Signed JEFF PETERSONContractor Cornejo /
WBCARTER (Subcontractor)Date 5-9-01
WEDNESDAYProject CENTRAL / RIDGE Rd IntersectionProject Number 472 83057000 001 / Index Code 706805

SWS change:

See Drawing ON BACK

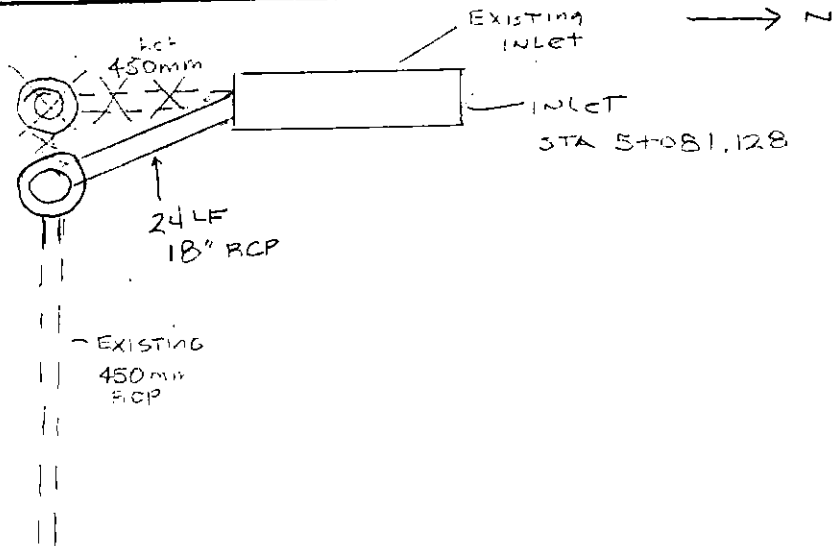
REMOVED SWS MANHOLE IN TOTAL DRIVEWAY STA

REMOVED SWS PIPE 18" RCP

USED EXISTING FLOWLINE GRADE @ INLET LAID 18" PIPE SOUTHEASTERLY

Removed 18" RCP SOUTH TO MH
Removed MH @ STA
